Final Decision Type II Staff Report

File number(s): DR 21-09 & EXCP 21-06
Project name: Valley Pacific Floral
Date of decision: December 2, 2021
Date of mailing: December 3, 2021
Applicant: Cindy Kelly-Wurdinger, Owner, Valley Pacific Floral
Landowner: Brown, Timothy R.
Site location: 2515 Newberg Highway
Tax Lot(s): 052W12AD18600

The applicant applied for Design Review (DR) 21-09 and Exception to Street Right of Way and Improvement Requirements ("Street Exception", EXCP) 21-06 to construct a flower shop at 2515 Newberg Hwy. The Street Exception application was included to request to maintain Newberg Hwy improvements as they exist today and not dedicate additional right-of-way along Country Club Rd.

Figure 3.01B – Major Arterial

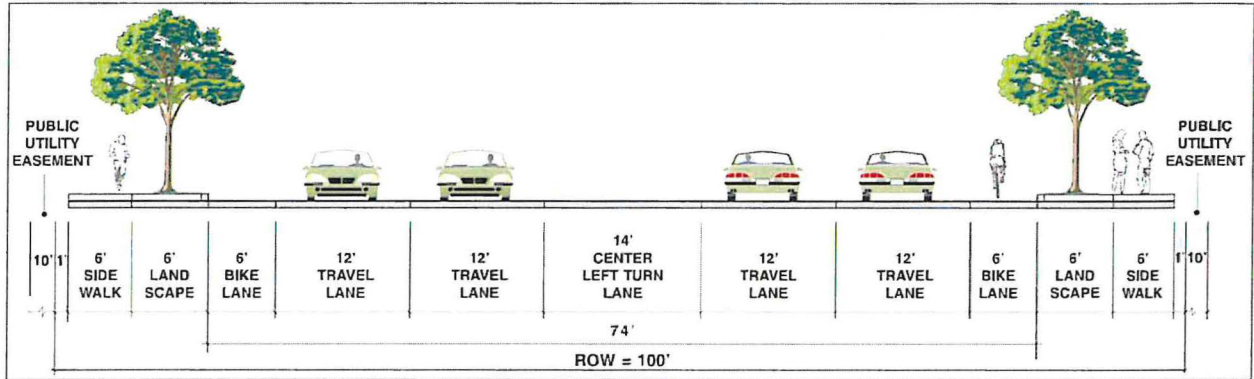
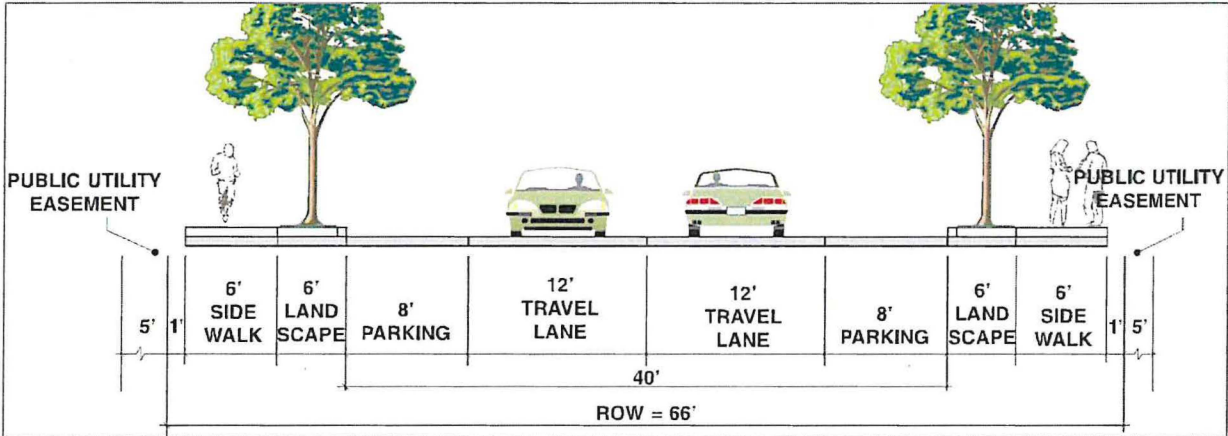
The applicant included a Street Exception request to maintain existing Newberg Highway improvements and not dedicate additional ROW along Country Club Road. Comparing the existing conditions of Newberg Highway to Figure 3.01B, the only nonconforming element is the curbtight sidewalk, which does not match the 6-ft landscape strip and 6-ft buffered sidewalk design. ROW width along the Country Club Road frontage varies due to the intersection with Newberg Highway, however plans appear to show a 3-foot dedication would be required to meet the minimum half-street width of 33 feet from centerline for an Access Street.

EXCP-1. Required half-street improvements along the subject property's Country Club Road frontage are illustrated on the approved plans and include curb, 6-foot wide landscape strip with street trees, 6-foot wide sidewalk, and 1-foot buffer. Because these improvements will not be entirely located within existing Country Club Road right-of-way, the applicant shall record with Marion County a public easement wide enough to encompass the portion of improvements that encroach within private property. Improvements and proof of recordation are due prior to building permit final inspection.

25 SITE PLAN
OPTION 2
1"=20'-0"

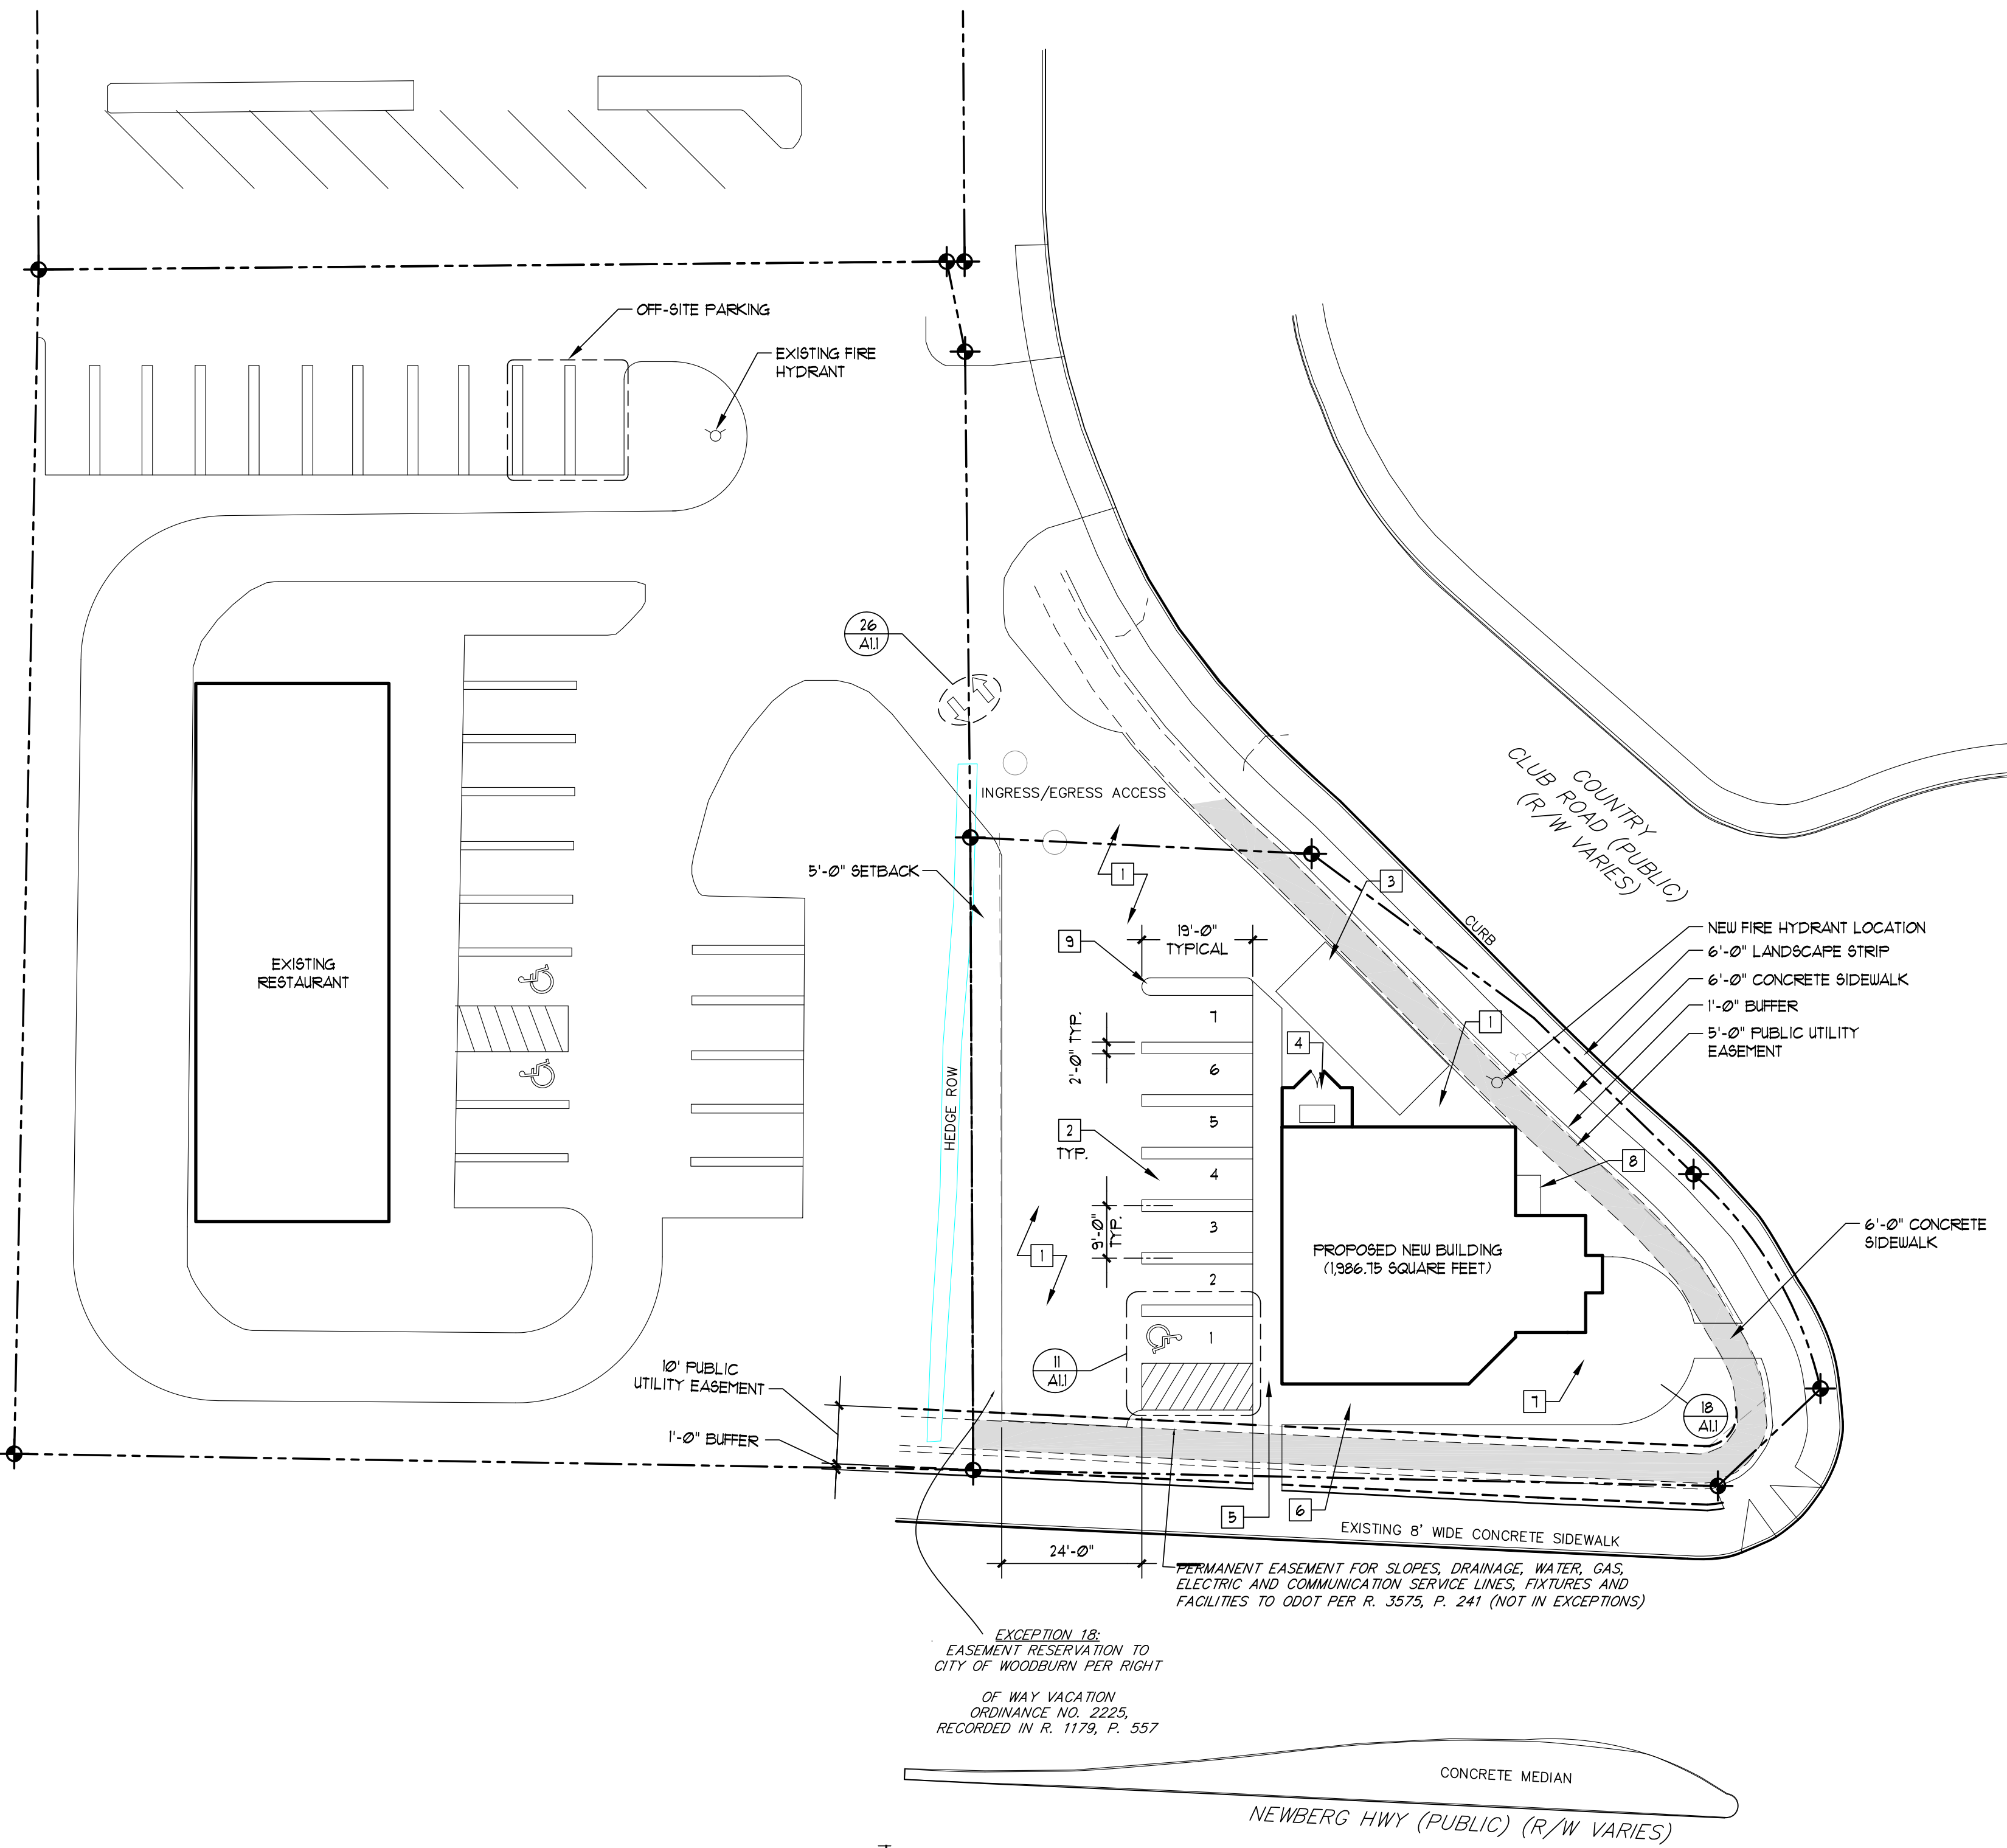
The application materials indicate the proposed flower shop building will be 1,986.75 square feet therefore the resulting minimum parking requirement is 8 parking stalls. Plans illustrate seven parking stalls provided on-site, one of which is designated as a van accessible stall. The narrative notes the eighth required parking stall will be provided off-site at 2288 Country Club Road (Tax Lot 052W12AC05800), which is also within the CG zone.

- DR-1a: Pursuant to 3.05.02B2, the applicant shall record a shared parking agreement to establish use of one parking stall on the neighboring property 2288 Country Club Rd.
- DR-1b: Revise plans to illustrate the required bumper guards for parking stalls abutting the walkway to comply with 3.05.02H.
- DR-1c: Revise plans to illustrate and note the on-site accessible stall as a “Van Accessible Stall” to comply with Table 3.05B.

- a. Pursuant to WDO 3.05.02B.2., record with Marion County a shared parking agreement between the subject property and 2288 Country Club Road (Tax Lot 052W12AC05800) to establish use of one parking stall for the proposed development. This is due prior to building permit final inspection.
- b. To meet WDO 3.05.02H., revise plans to illustrate or note the required bumper guards for parking stalls abutting the walkway. This is due prior to building permit issuance.
- c. To meet WDO Table 3.05B, revise plans to illustrate and note the on-site accessible stall as a "Van Accessible Stall" with the appropriate signage and striping. This is due prior to building permit issuance.

PRELIMINARY
PLANTING
PLAN

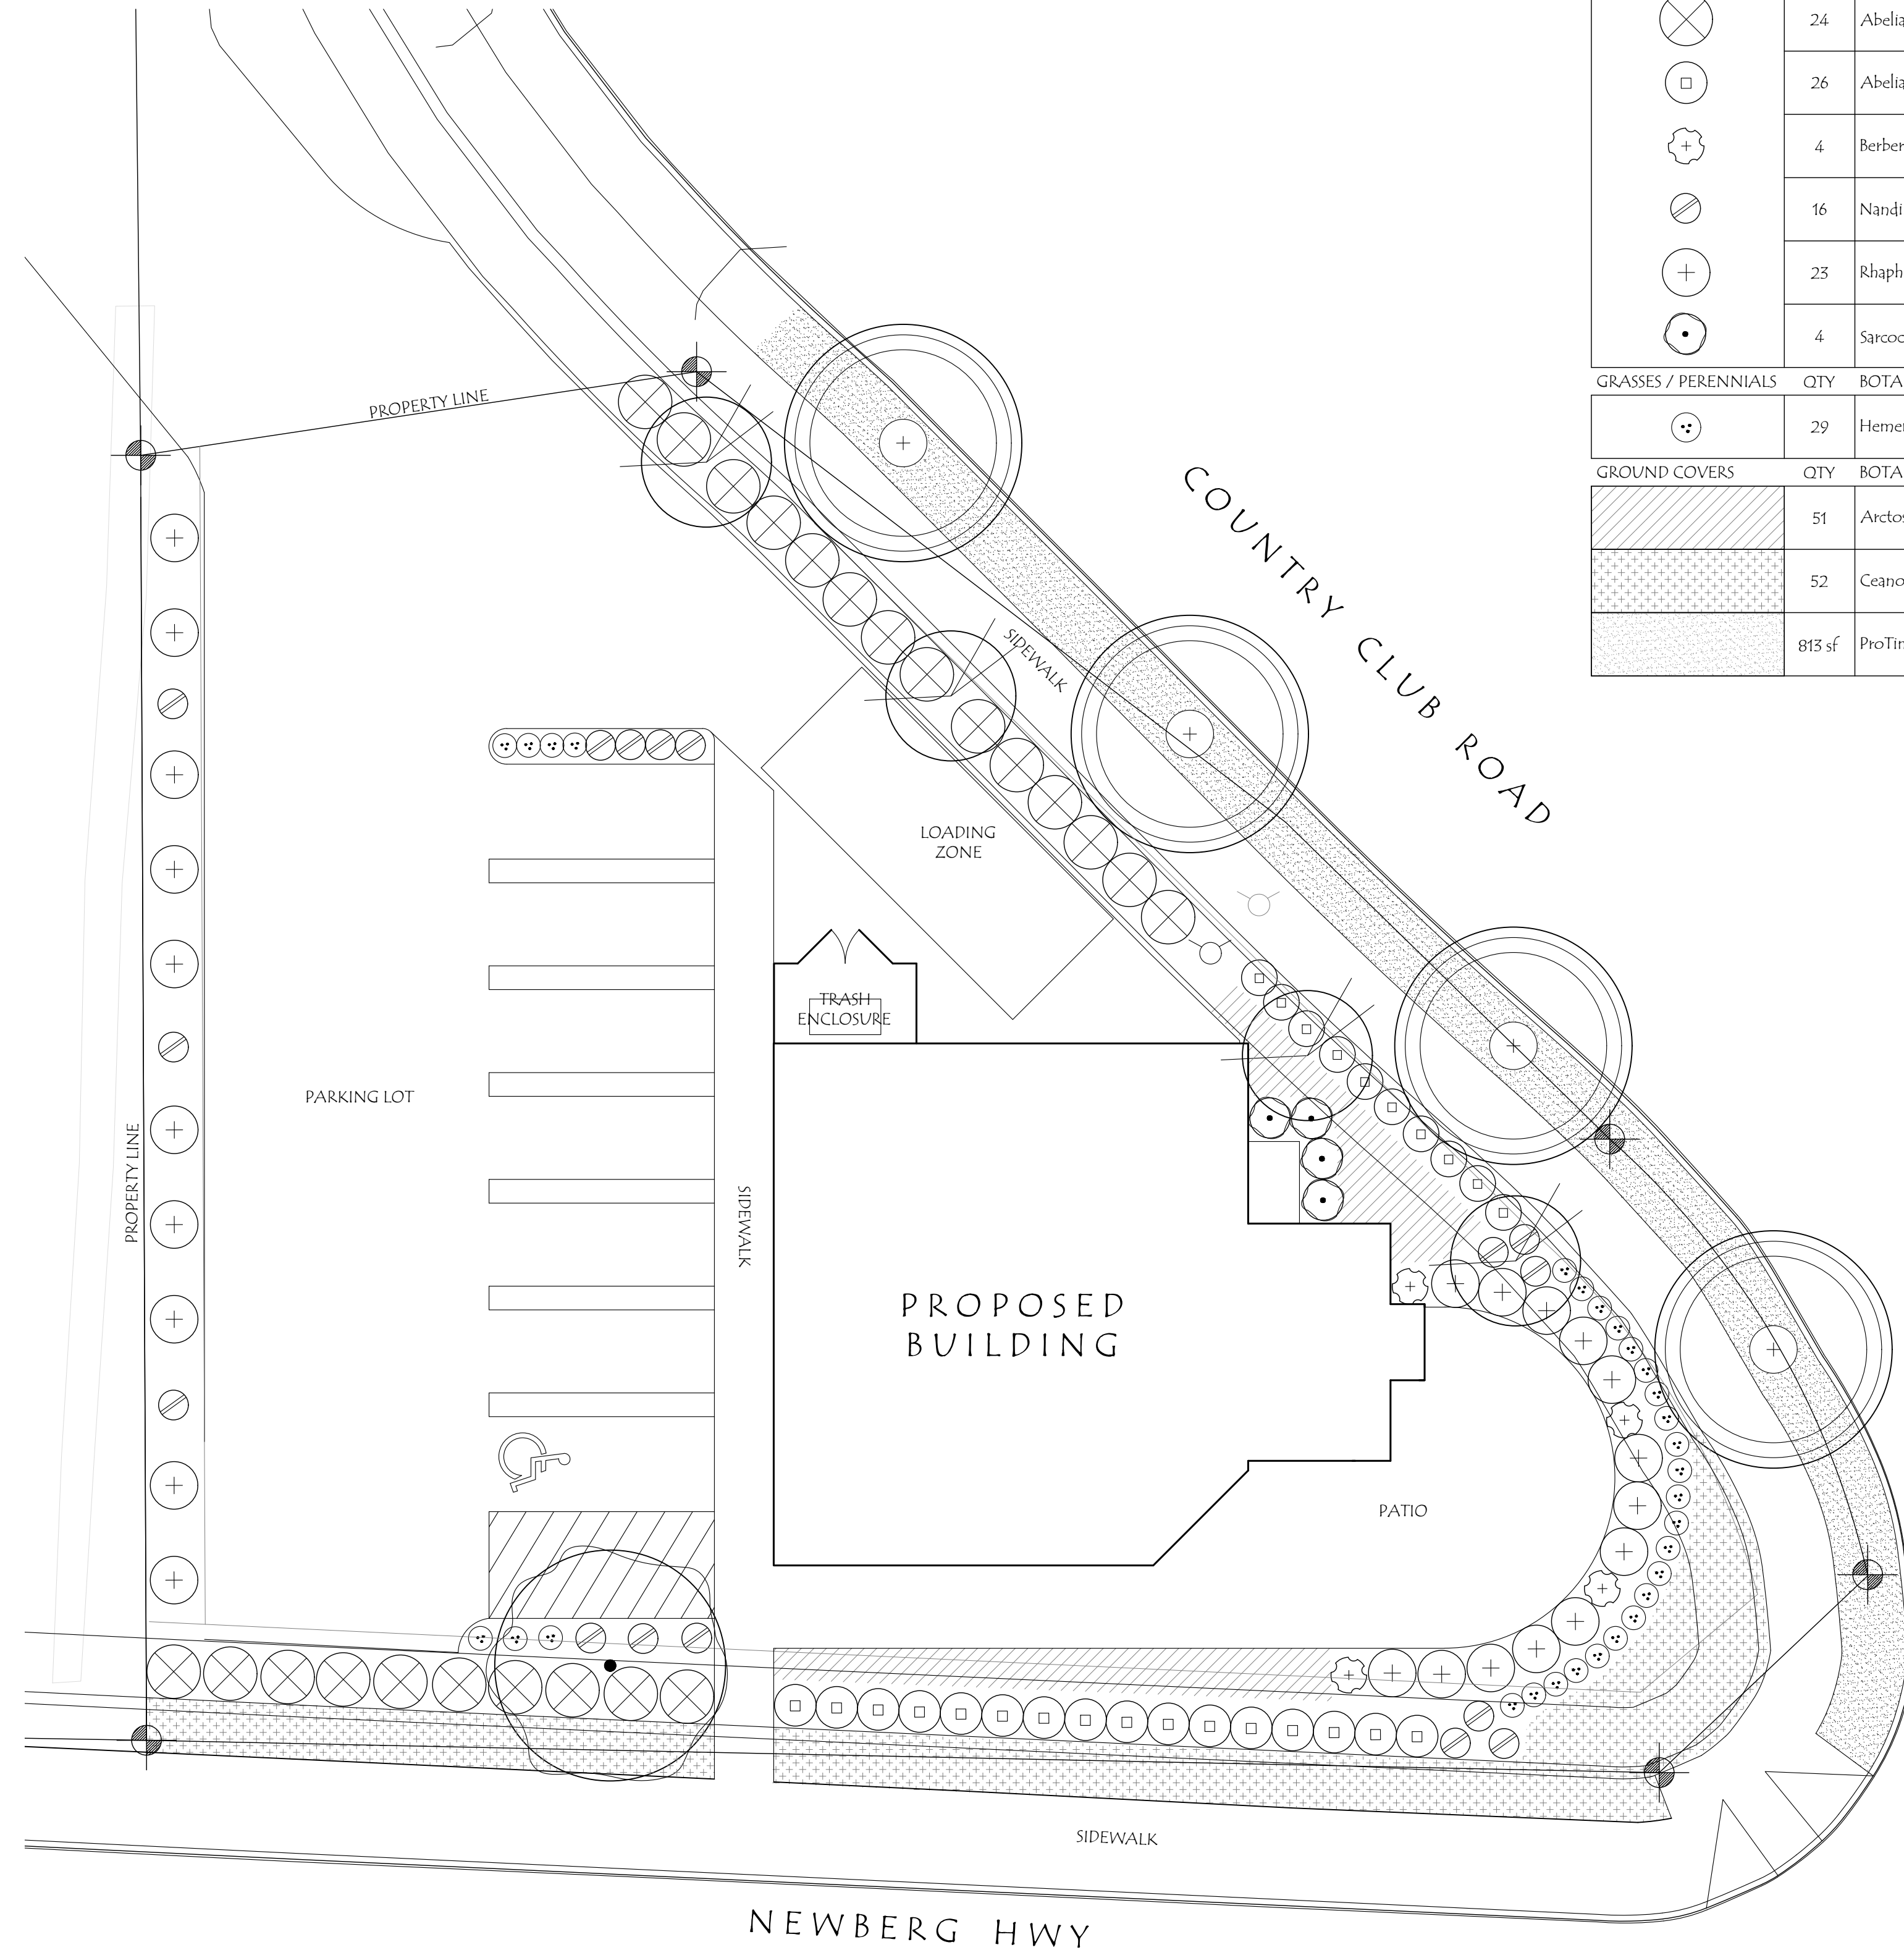
Plans note the subject property has approximately 147.25 feet of frontage along Newberg Highway, a Major Arterial street, and approximately 183.63 feet of frontage along Country Club Road, an Access street. The associated street tree requirements are therefore two large street trees along Newberg Highway and three medium street trees along Country Club Road. The landscape plan illustrates one tree on private property along the Newberg Highway frontage

and four medium trees within the landscape strip along Country Club Road. The applicant included a Street Exception request to maintain the existing curbtight sidewalk along Newberg Highway, and 3.06.03A.3. allows street trees within private property, therefore the tree along Newberg Highway can count as a street tree. Staff adds *Condition of Approval DR-2* to update the landscape plan with a second street tree along the Newberg Highway frontage.

DR-2. Street trees: To meet WDO 3.06.03A., revise the landscaping plan to include at least two large trees along the frontage of Newberg Highway. This is due prior to building permit issuance.
